ADDENDUM NO. 4

FIRE STATION NO 6 GEORGETOWN, TEXAS

DATE: December 14, 2018
PROJECT NO: 217079.00.00

The Construction Documents on the above referenced project, dated 11/16/2017, shall be revised as follows:

AD4.1

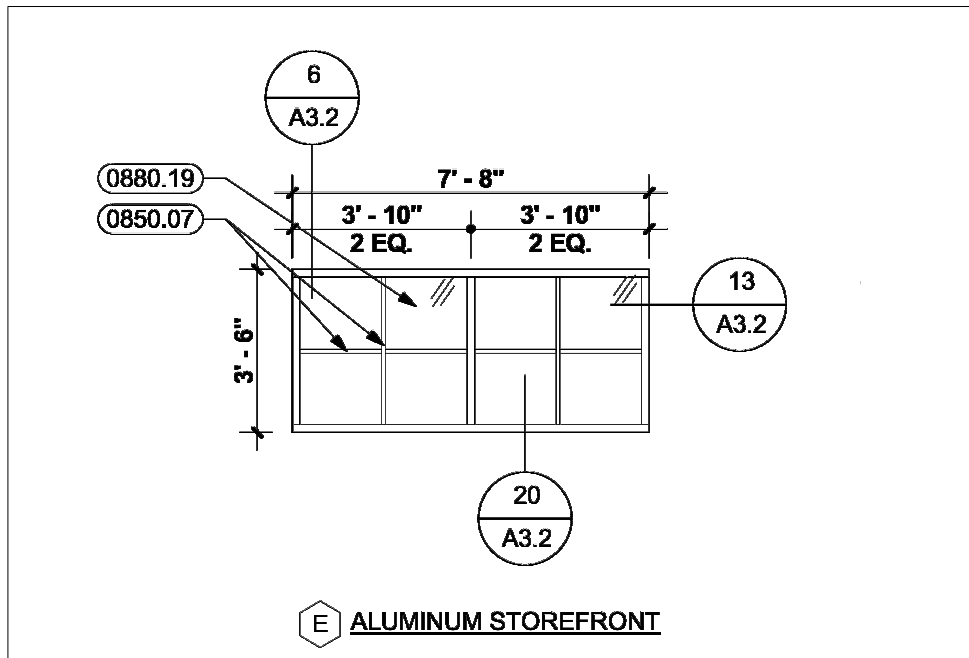
Item No. 7 (Drawing Sheet A3.1) Window Types. The dimensions were cut off in the drawing of Window Type E. The detail has been attached to this addendum. See Attached **Drawing AD4.1**

C3.0
 SITE UTILITY PLAN

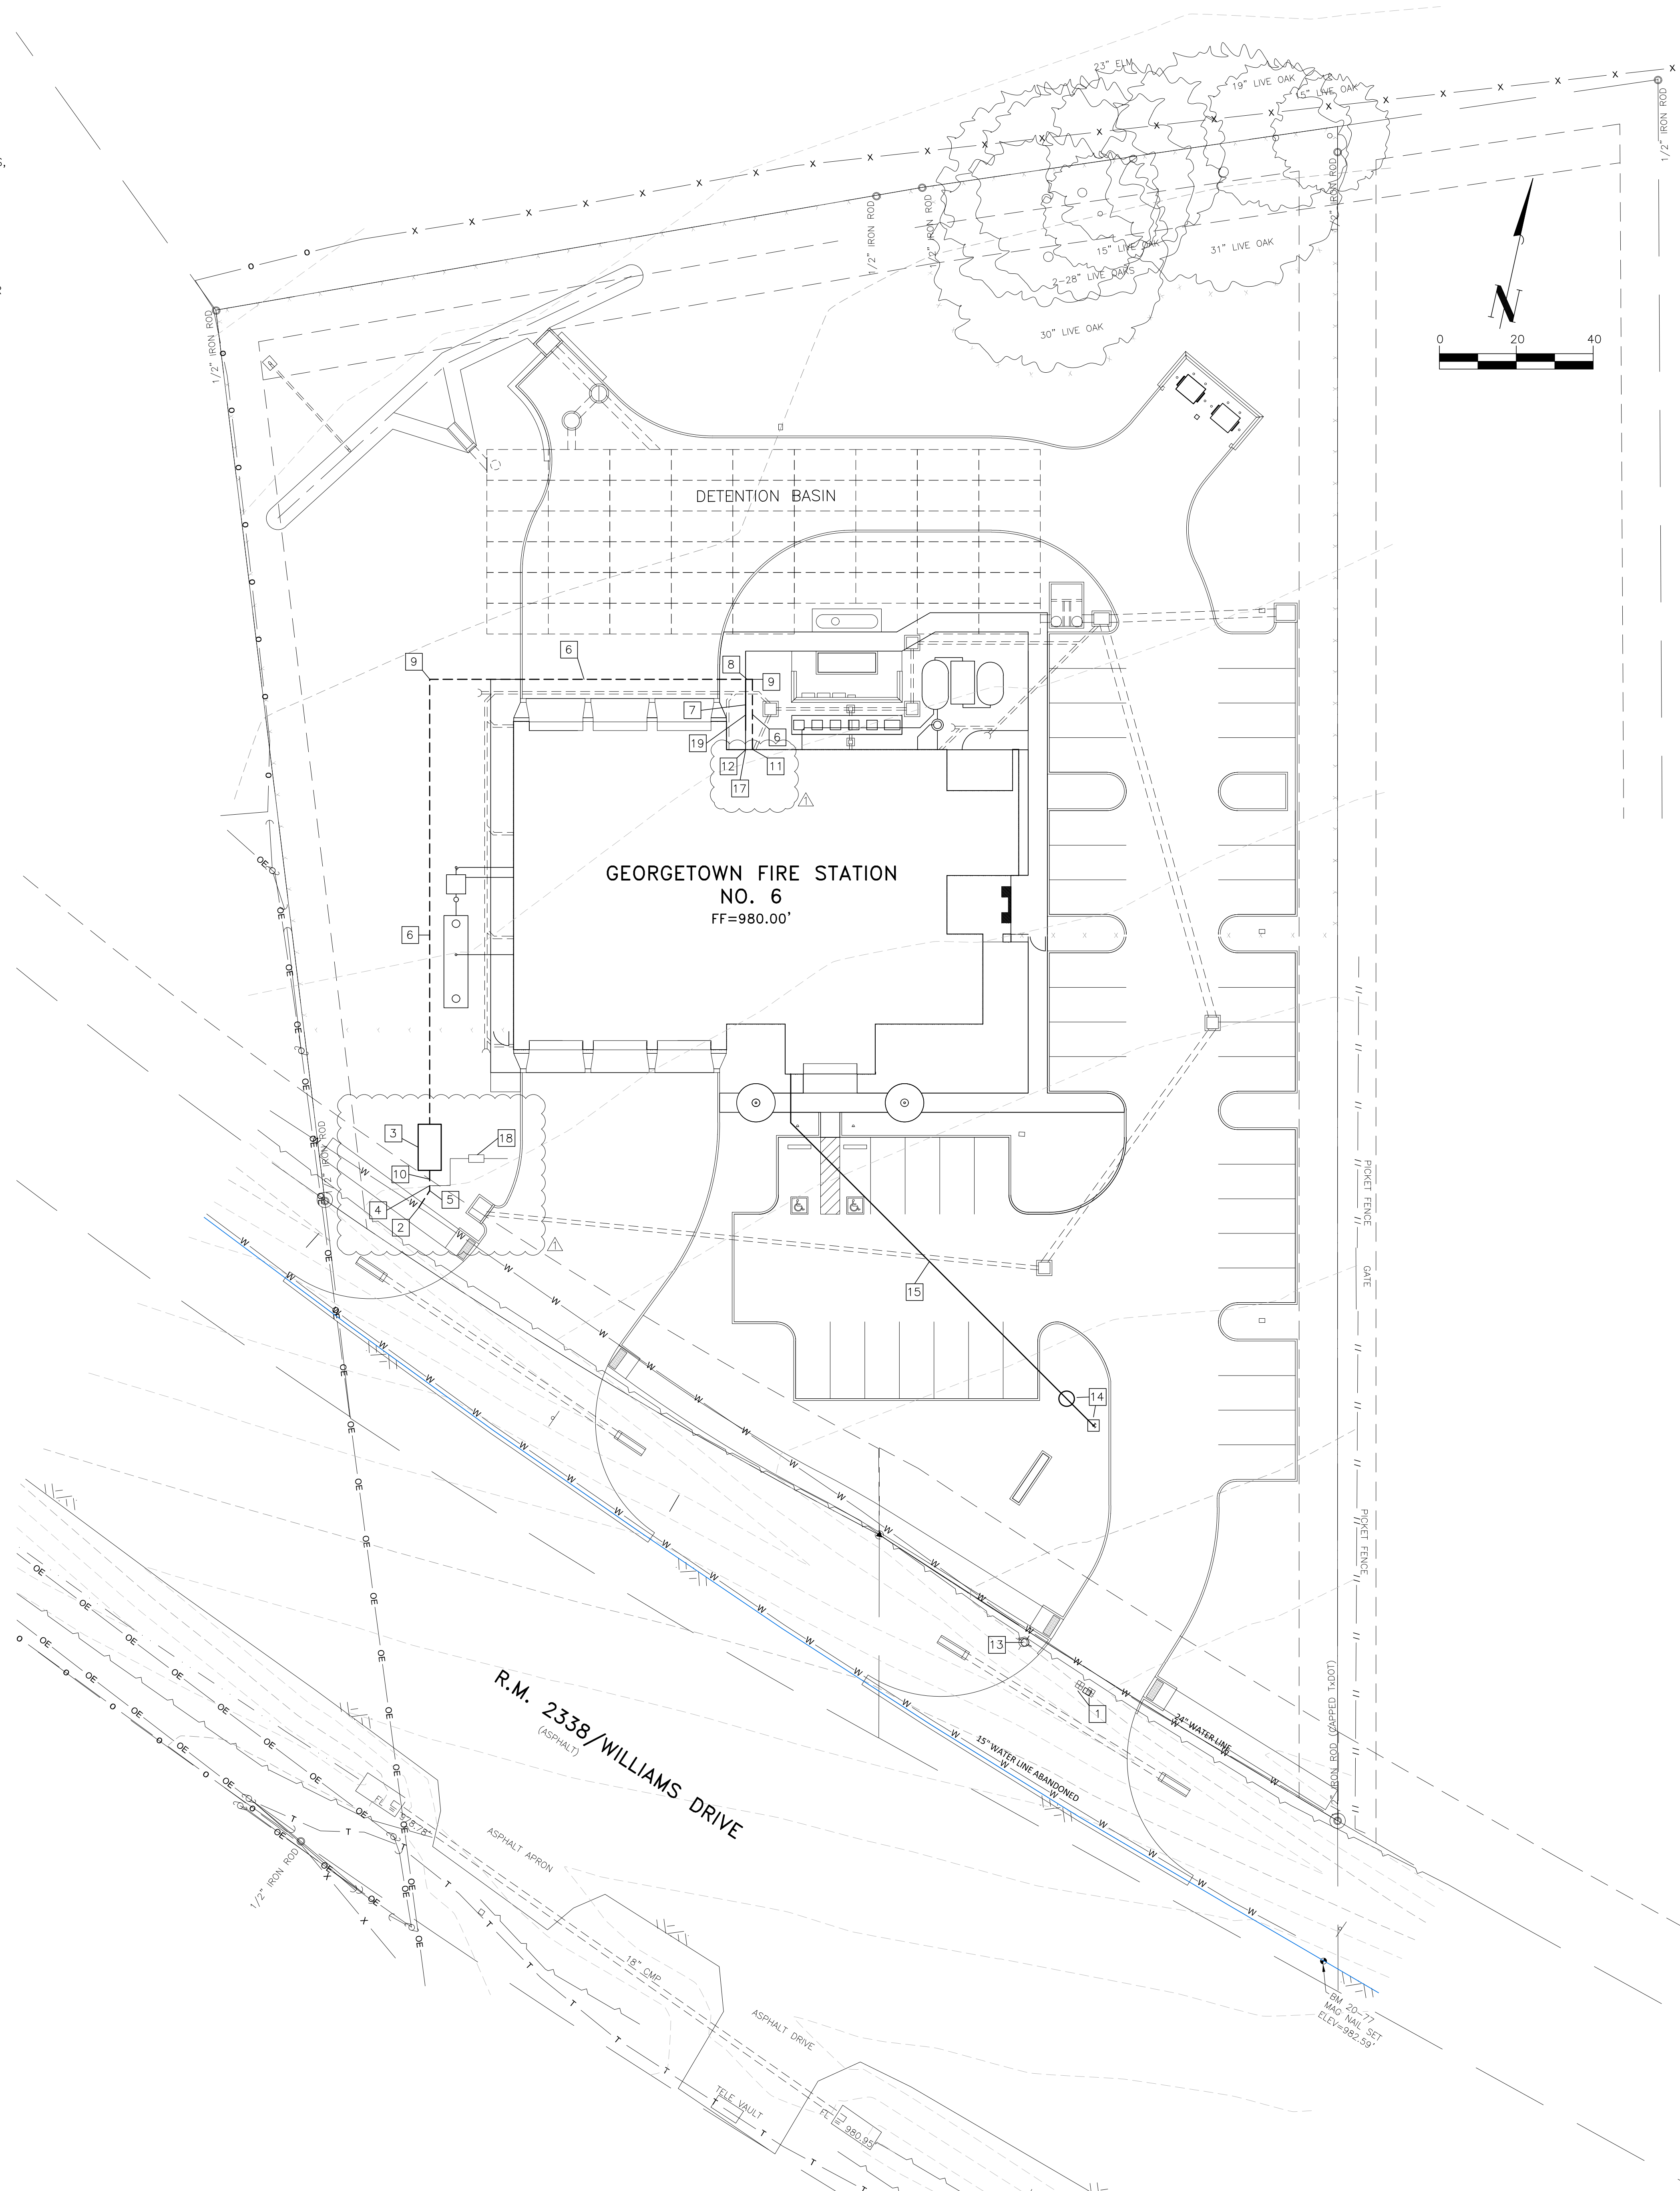
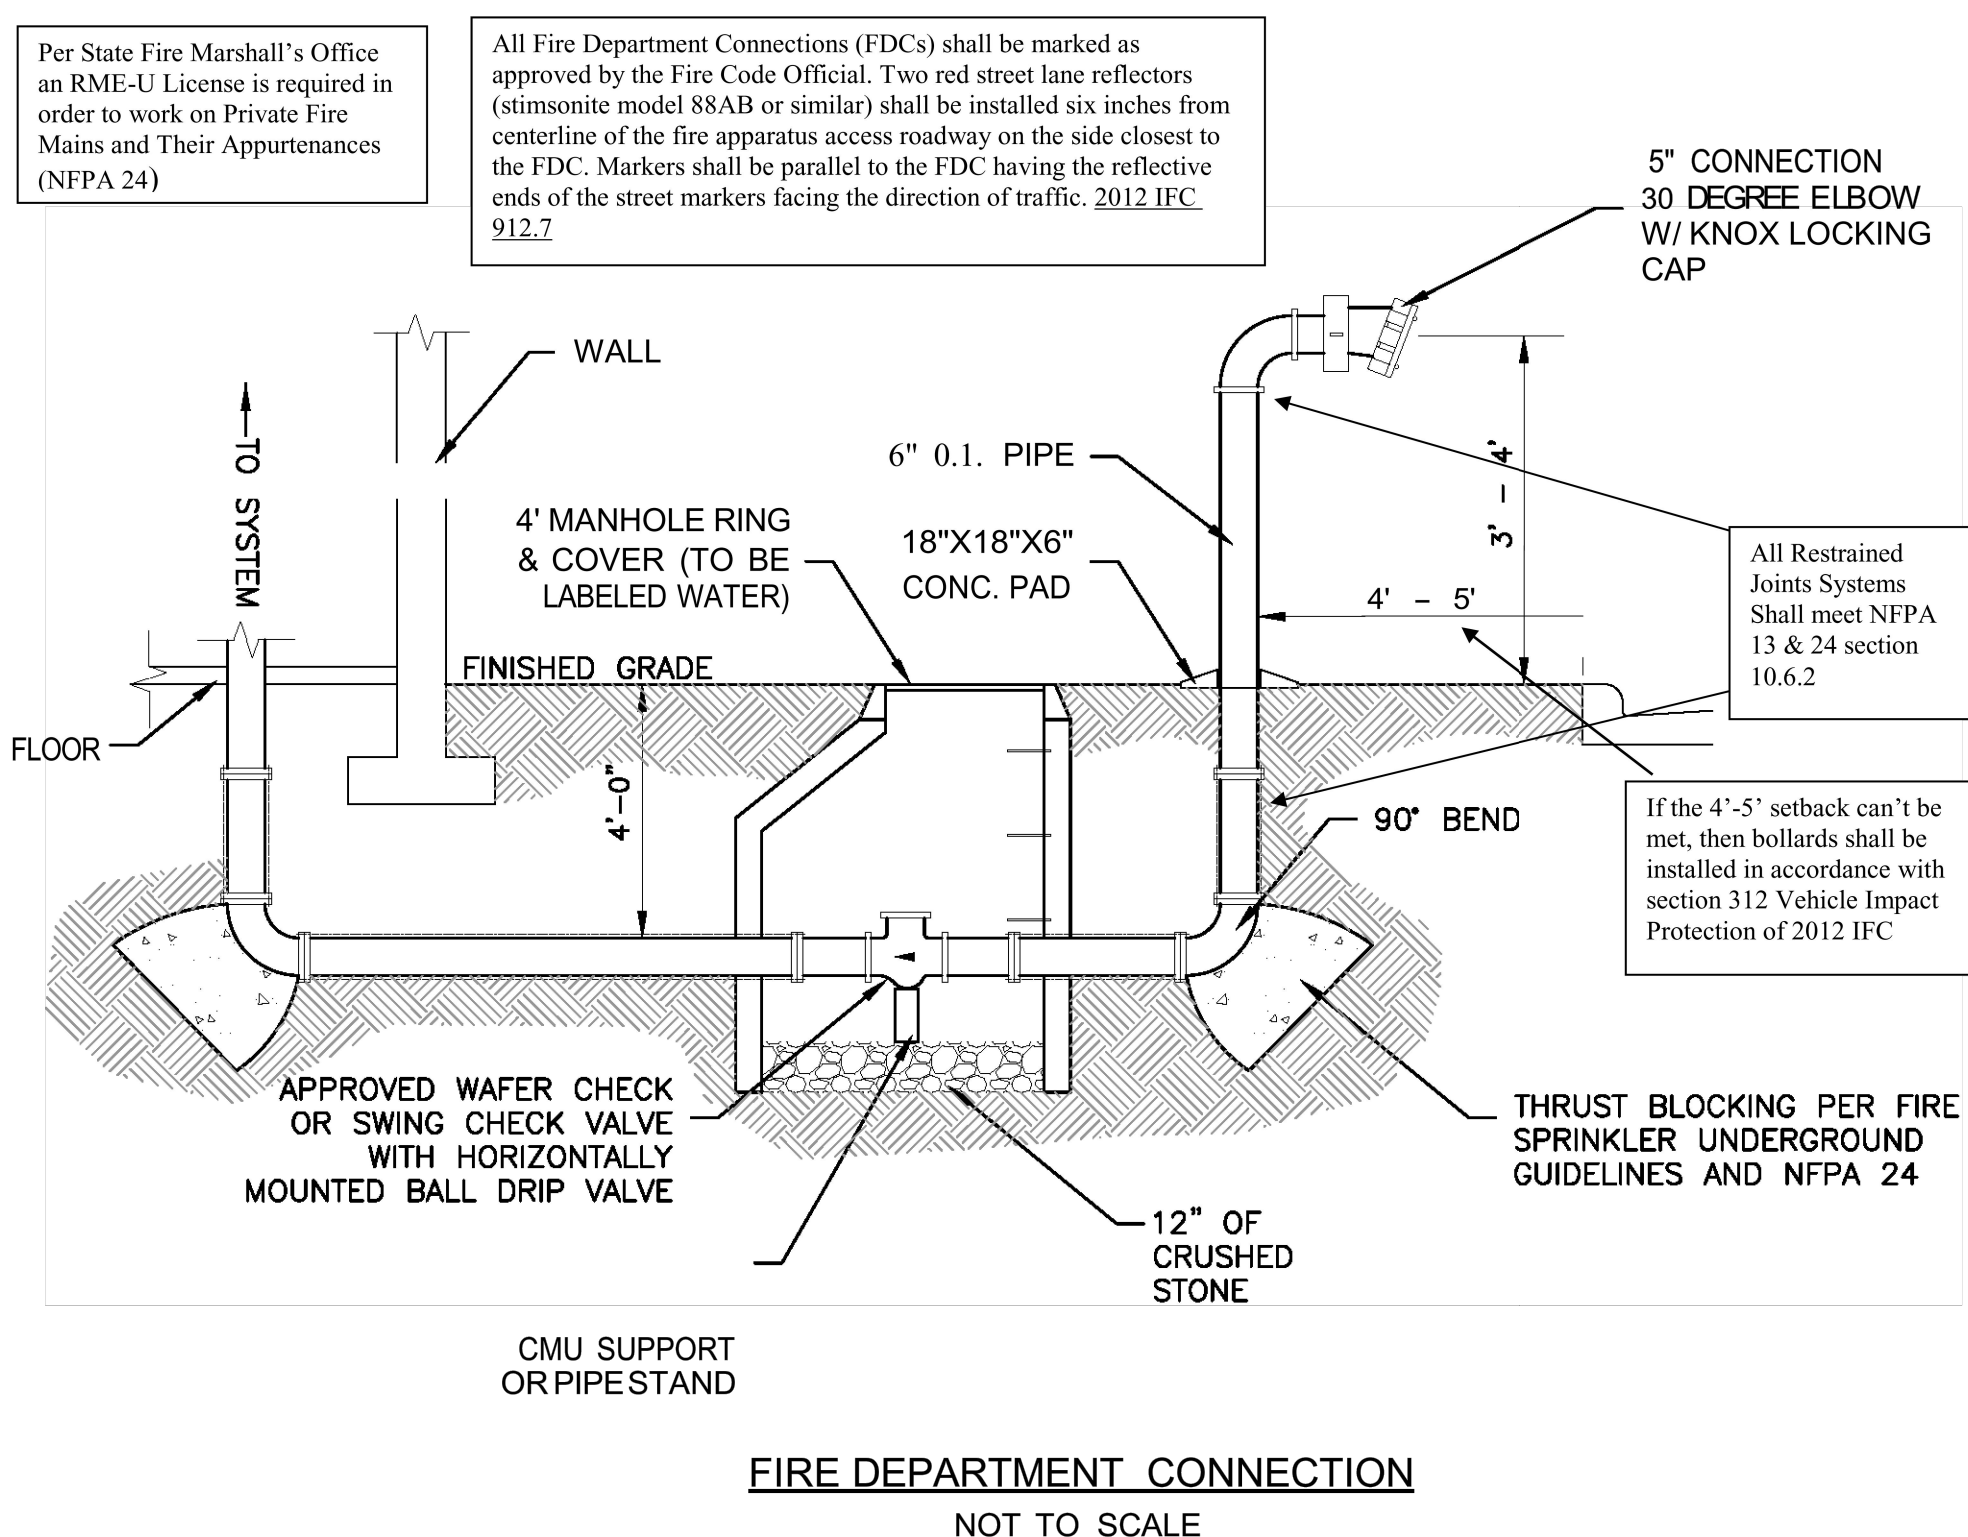
Item No. 3 (Drawing Sheet C3.0) An un-labeled box has been removed adjacent to the water meter box. Please reference Drawing Sheets C5.0 & C5.1 for City of Georgetown Water Details. See Attached Revised **Drawing Sheet C3.0**
